HOPKINTON ESTATES SUBDIVISION

APPLICATION NUMBER 1 DATE December 20, 2007

REQUEST Subdivision

DETAIL SITE PLAN

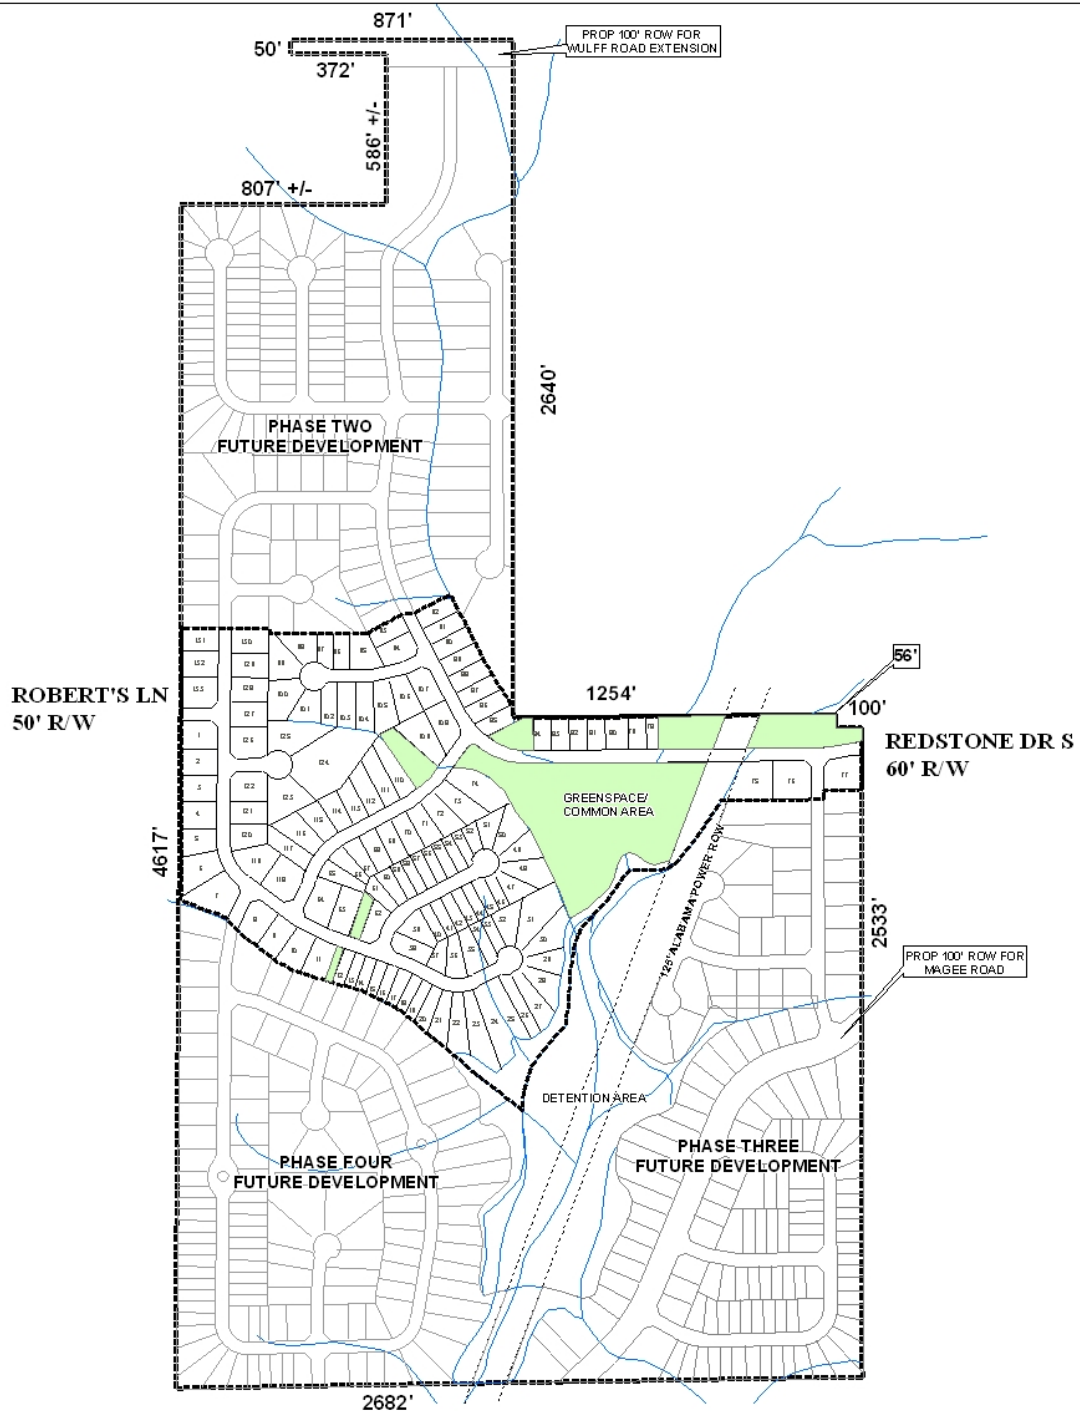
The 25-foot minimum building setback line, required in Section V.D.9., is not shown for the subdivision, but would be required on the final plat, if approved. The setback line should also be depicted for the common areas.

The revised plat depicts the 133-lot Phase One, which will connect Roberts Lane and Redstone Drive as part of the Phase One development. The direct connection to Old Wulff Road to the North has been eliminated from the plat.

The above lot sizes are estimates, and the number measured by staff as being below 7,200 square feet is less than the number claimed by the applicant (220 lots). As the individual lots are not labeled with their size in square feet, and as no table with the same information is provided, staff can only roughly estimate the size of lots. It should also be pointed out that the staff report for the Magnolia Springs subdivision stated that 160 lots, or approximately 17% of the development would be lots less than 7,200 square feet.

- 1) Limited to 133-lots for Phase One as proposed, with new individual Subdivision applications required for any future phase;*
- 2) Provision of an ITE compliant traffic impact study by a third party engineering firm for the entire proposed 523-lot subdivision with the next Subdivision application for any future phase;*

- 4) Provision of temporary turn-arounds for all street-stubs longer than 150-feet, linking to future phases;*

- 16) *Revision of the plat to label each lot with its size in square feet, or placement of a table on the plat with the same information; and*
- 17) *Placement of a note on the final plat stating that any lots which are developed commercially and adjoin residentially developed property must provide a buffer, in compliance with Section V.A.7 of the Subdivision Regulations.*
